## AMENDMENTS TO THE DRAWINGS

Appln. No. 09/552,590  
Amend. Dated: 3/18/04  
Reply to Office Action of 12/19/03  
Replacement Sheet

FIG. 4

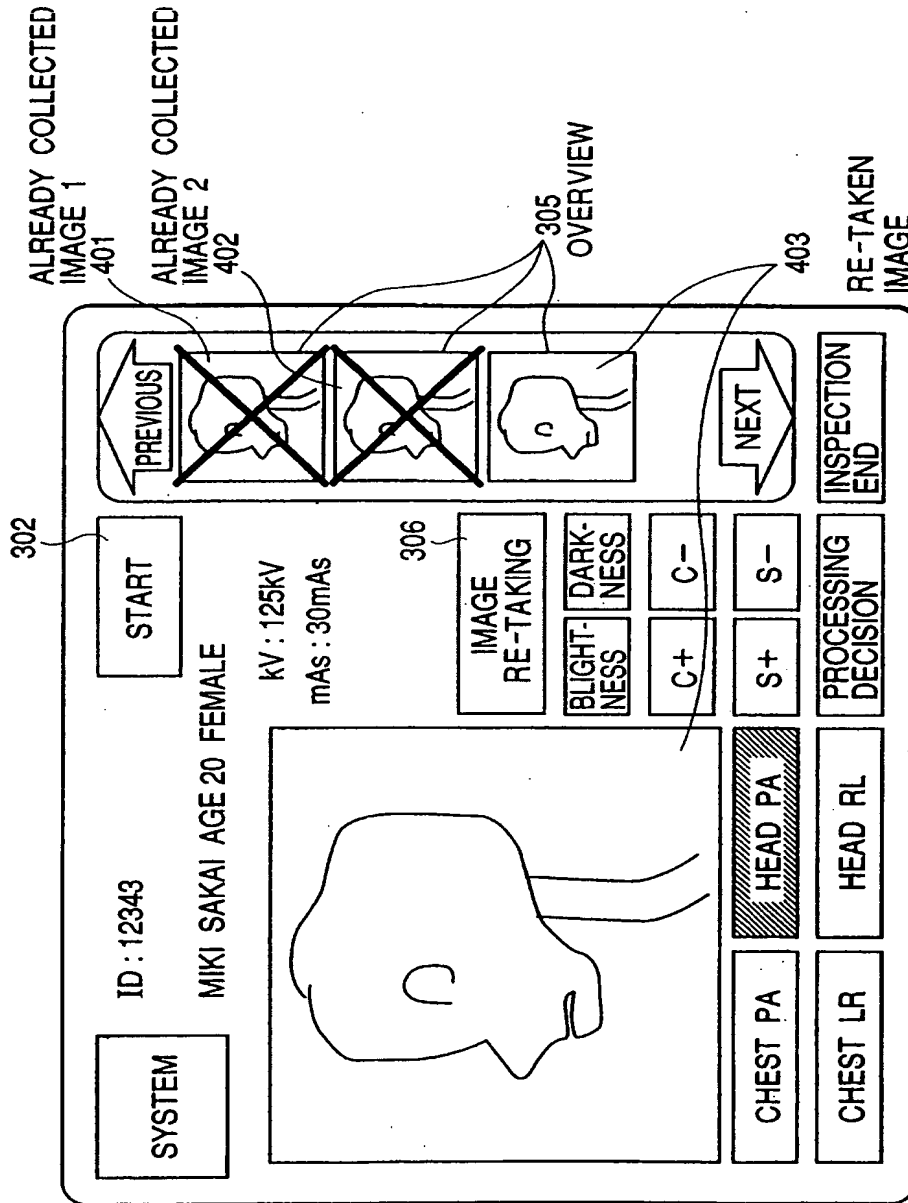
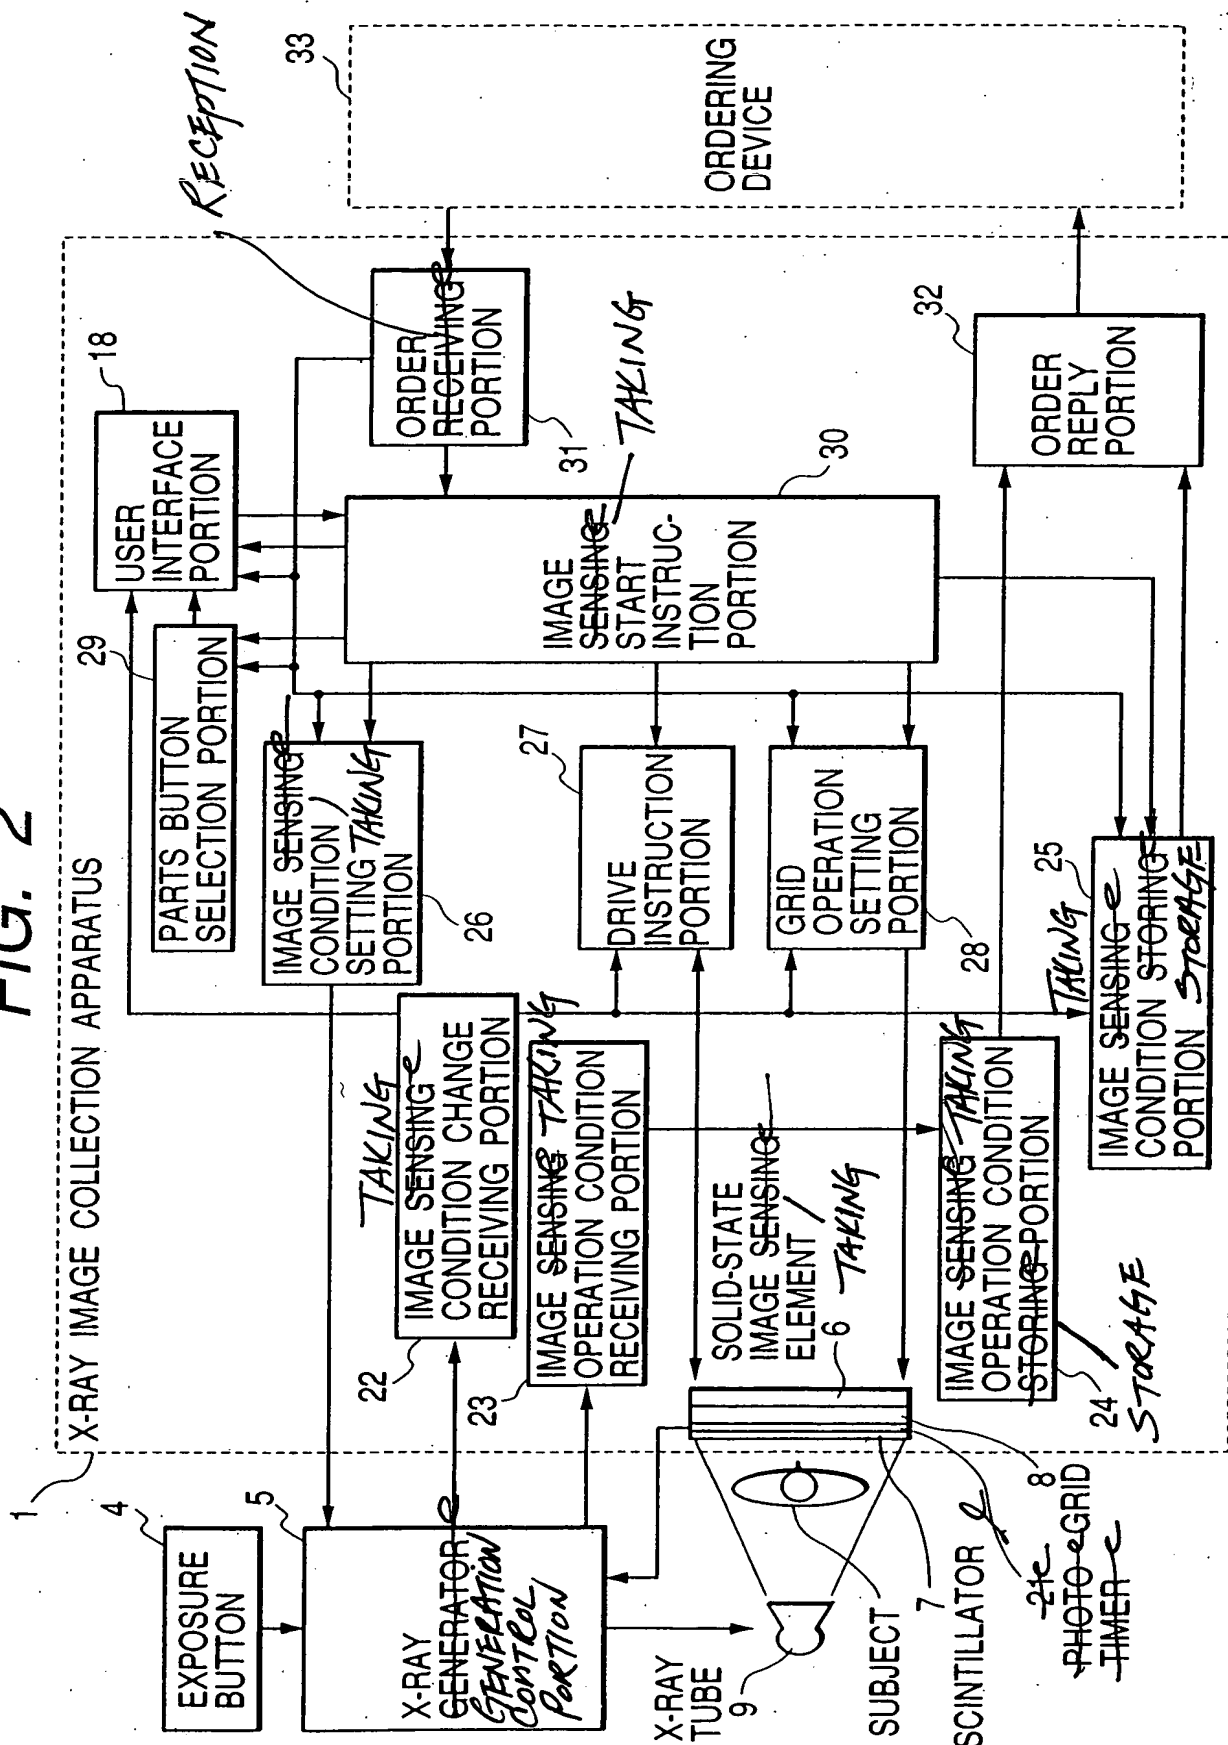
Fig. 4, change "RE-IMAGE SENSING" to --IMAGE RE-TAKING--, change "305 OVER VIEW" to --305 OVERVIEW--, and "403 RE-IMAGE SENSING IMAGE" to --RE-TAKEN IMAGE--.

FIG. 5

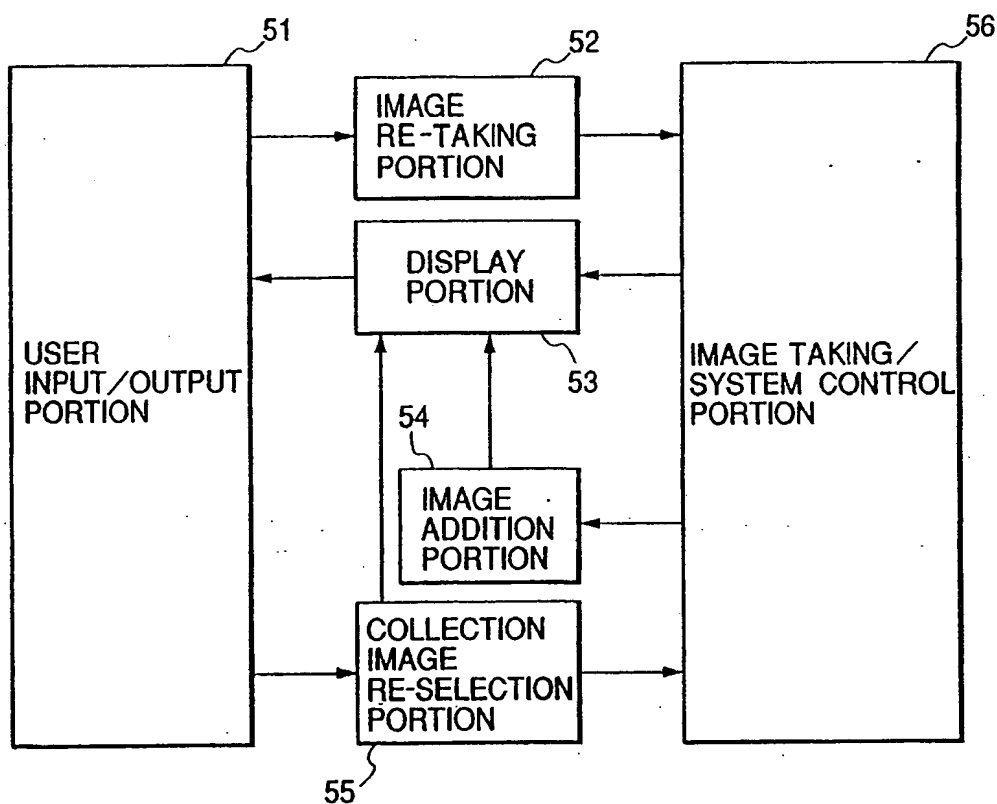
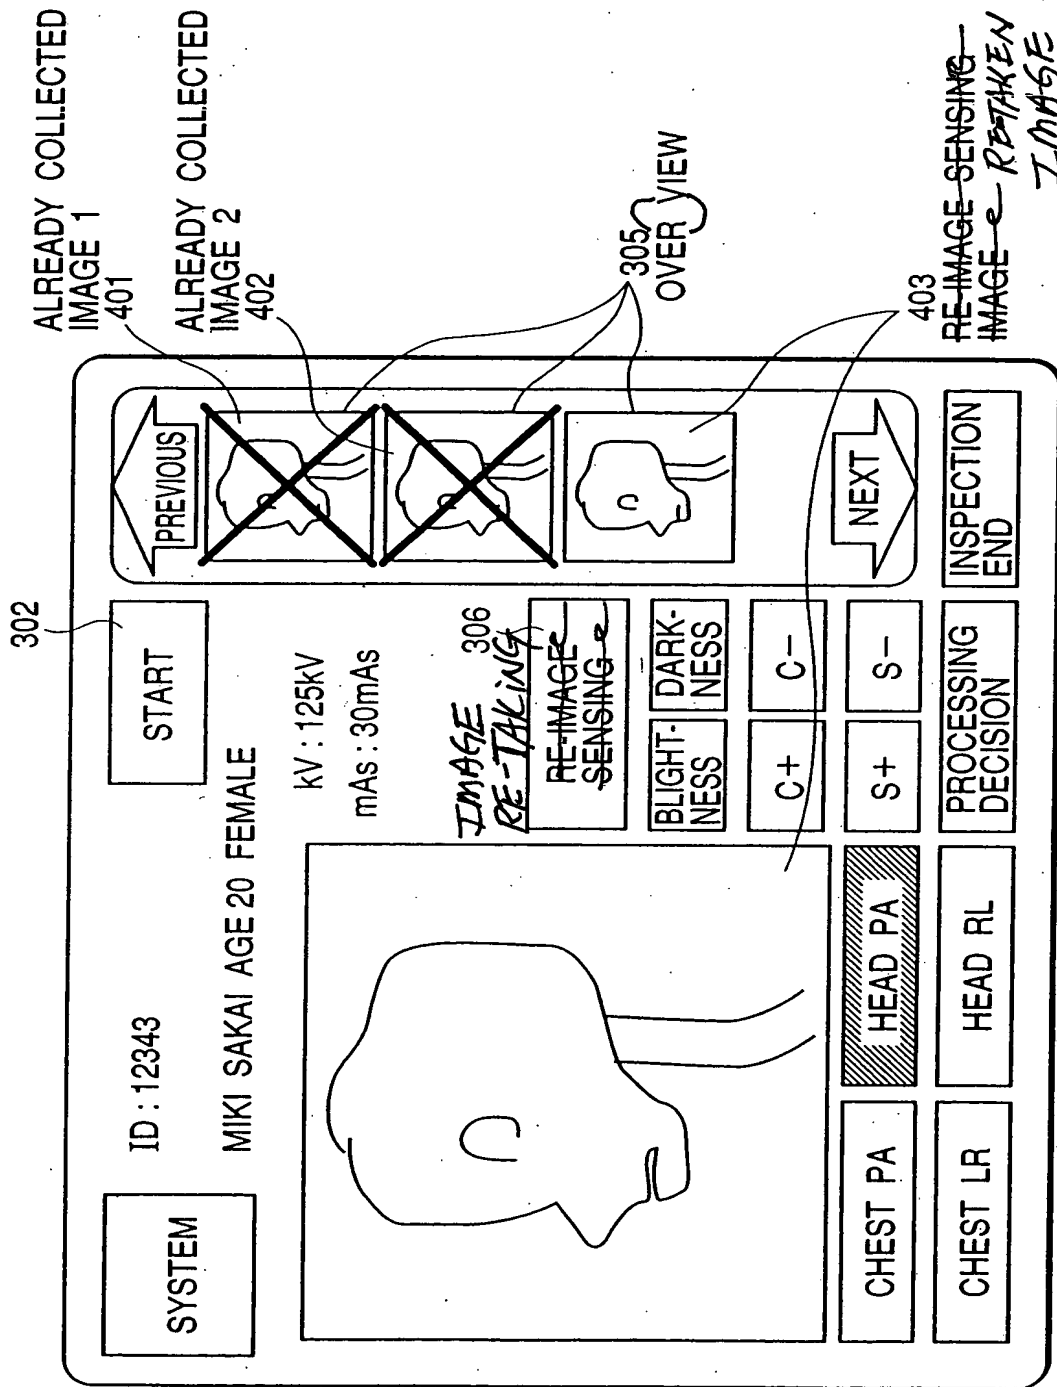
Fig. 5, change "RE-IMAGE SENSING INSTRUCTION PORTION" to --IMAGE RE-TAKING PORTION--, and change "IMAGE SENSING•SYSTEM CONTROL PORTION" to --IMAGE TAKING/SYSTEM CONTROL PORTION--.

FIG. 6

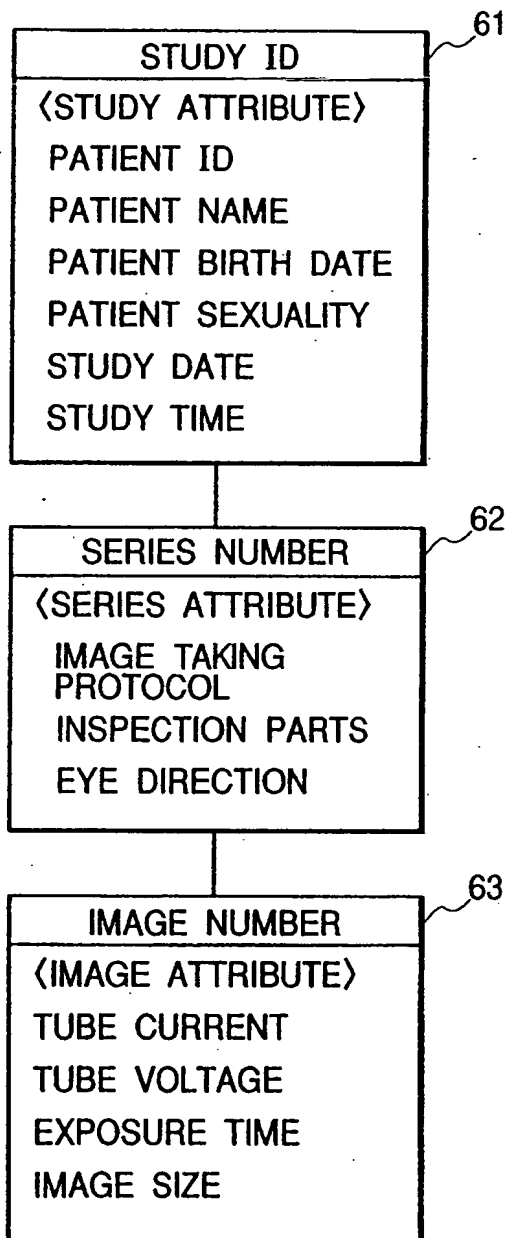
Fig. 6, change "IMAGE SENSING PROTOCOL" to --IMAGE TAKING PROTOCOL--.

FIG. 11

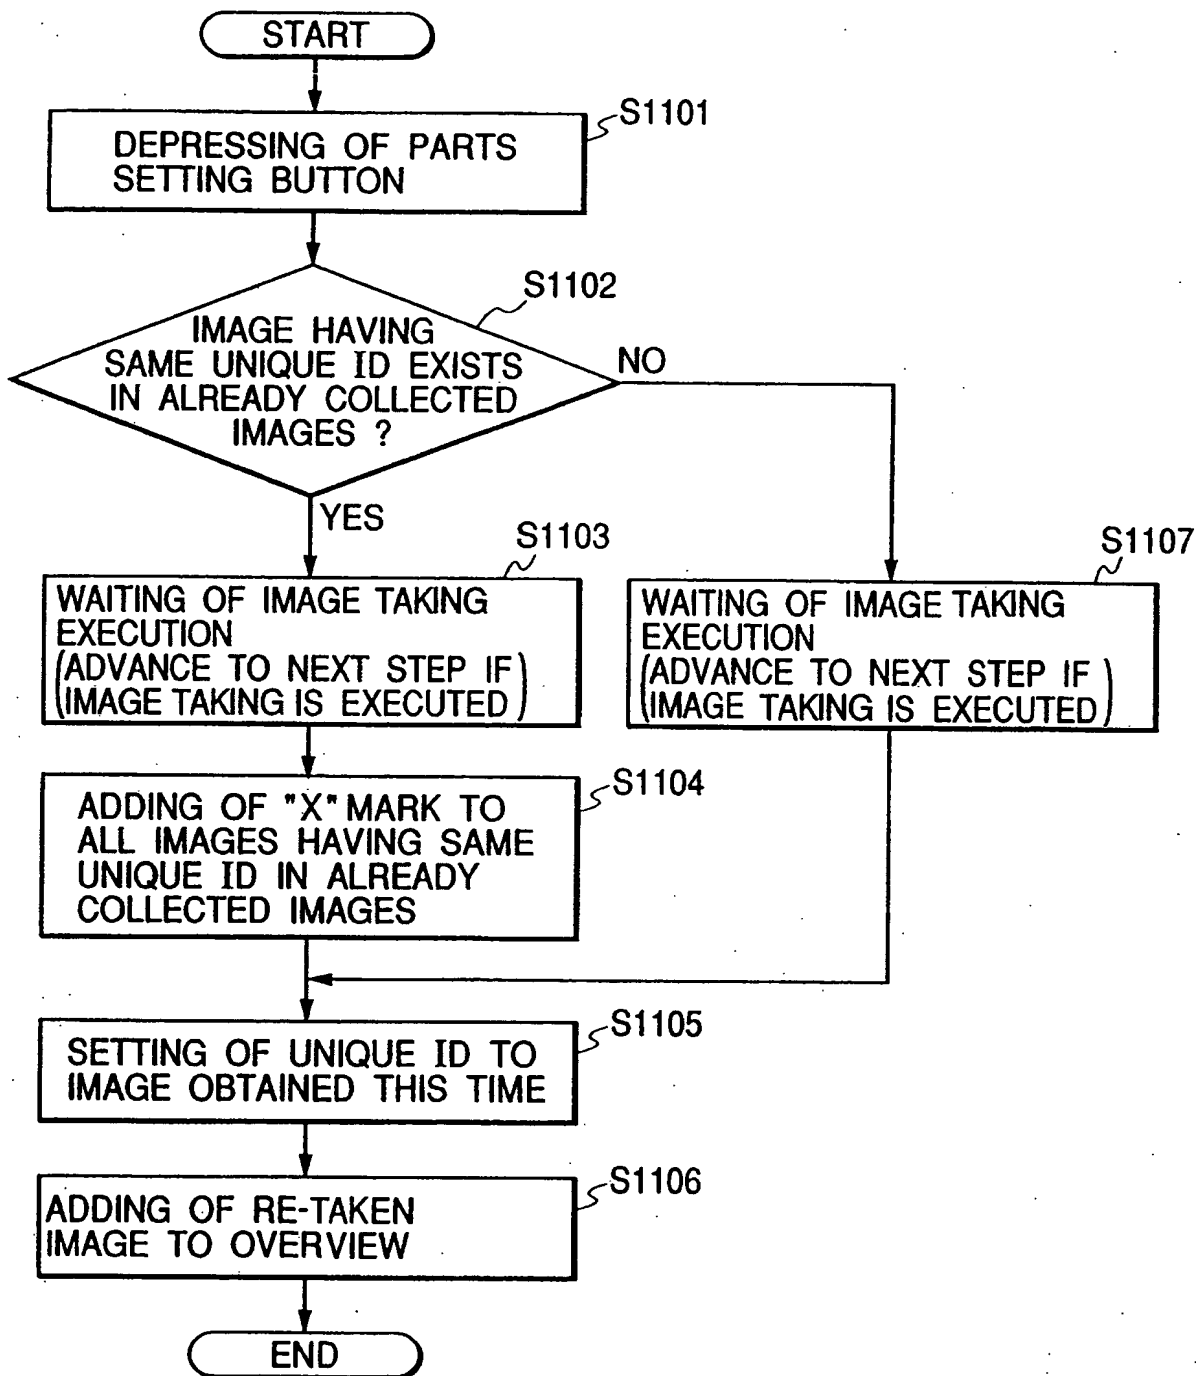
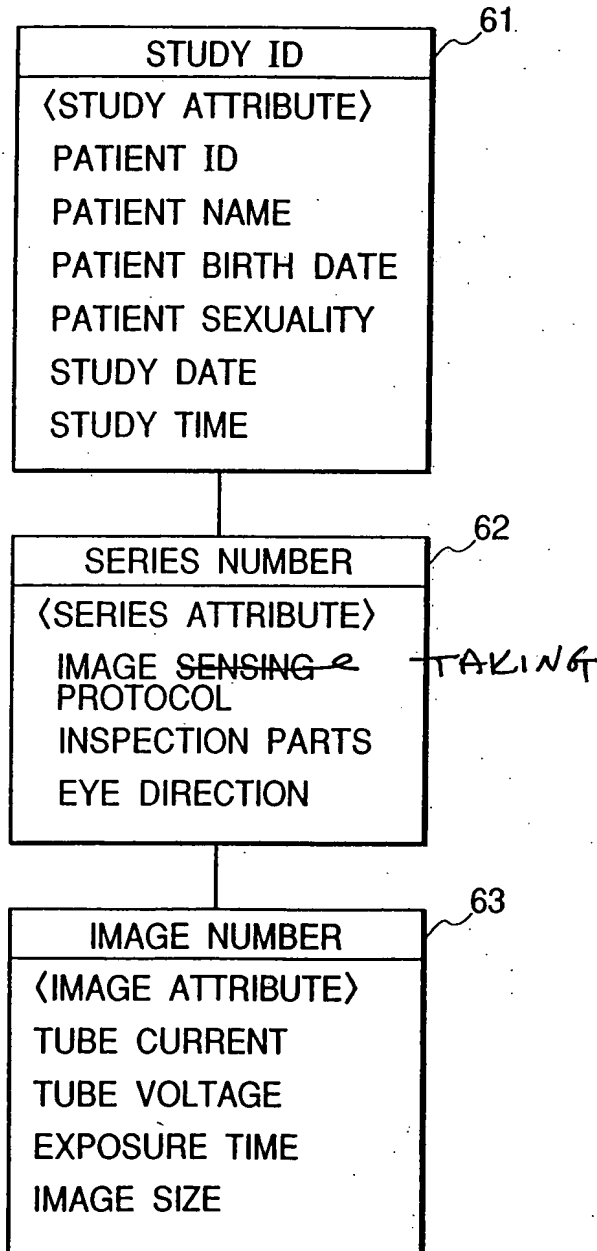
Fig. 11, change for S1103 "WAITING OF IMAGE SENSING EXECUTION (ADVANCE TO NEXT STEP IF IMAGE SENSING IS EXECUTED)" to --WAITING OF

IMAGE TAKING EXECUTION (ADVANCE TO NEXT STEP IF IMAGE TAKING IS EXECUTED)--, change for S1107 "WAITING OF IMAGE SENSING EXECUTION (ADVANCE TO NEXT STEP IF IMAGE SENSING IS EXECUTED)" to --WAITING OF IMAGE TAKING EXECUTION (ADVANCE TO NEXT STEP IF IMAGE TAKING IS EXECUTED)--, and change "ADDING OF RE-IMAGE SENSED IMAGE TO OVER VIEW" to --ADDING OF RE-TAKEN IMAGE TO OVERVIEW--.
